CITY OF ALBUQUERQUE

Re: Dia De Las Baristas
4915 Lomas Blvd. NE
Traffic Circulation Layout
Architect's Stamp 03-08-23 (J17-D006)

Based upon the information provided in your submittal received 03-15-23, the above referenced plan cannot be approved for Building Permit until the following comments are addressed:

TRAFFIC CIRCULATION LAYOUT

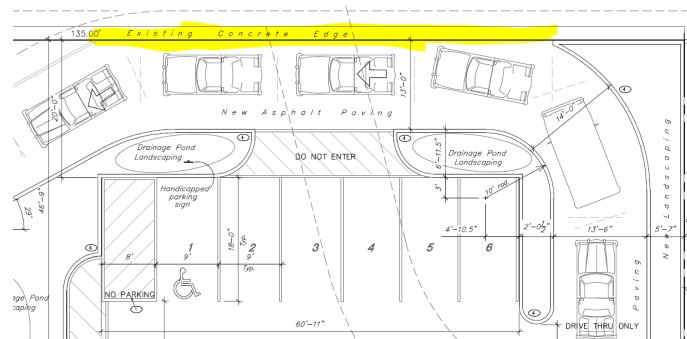
1. Identify all existing access easements and rights of way width dimensions.
2. Identify the right of way width, medians, curb cuts, and street widths on Lomas Blvd. NE and Quincy Ave. NE.
3. Per Ernest Armijo instruction, please close the edge of the drive-thru on the north side of the site. (suggestion: close it with a curb or barriers curb).

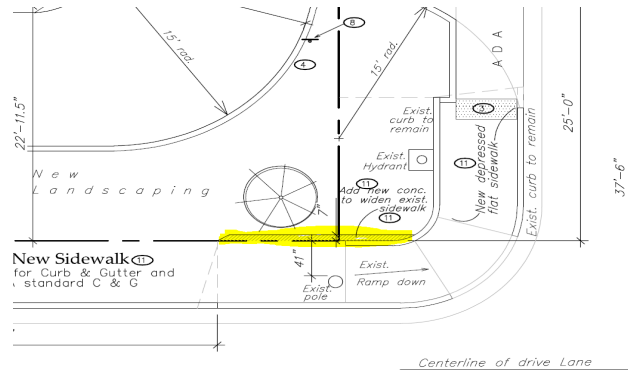
4. Please provide sidewalk easement for this proposed concrete to widen the existing sidewalk. For sidewalk easement, please contact Carrie Mouck @ camouck@cabq.gov

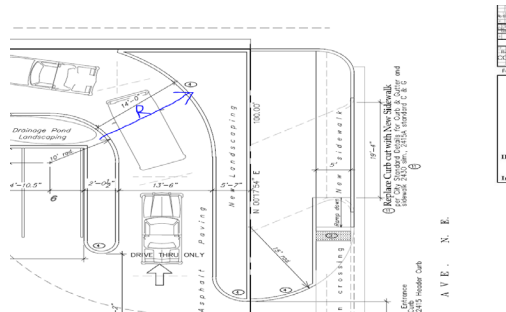
5. ADA curb ramp at the corner of Lomas and Quincy must be updated to current standards and have truncated domes installed.
6. Show on the site plan the radius for this area

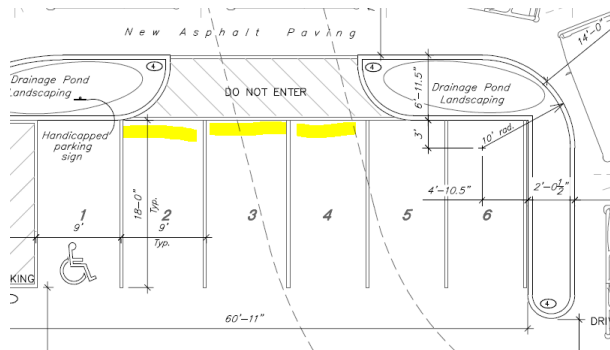
7. Please provide "One Way signs and pavement marking at the beginning of the drive-thru.
8. Curbing or Barriers curb should be installed in this area
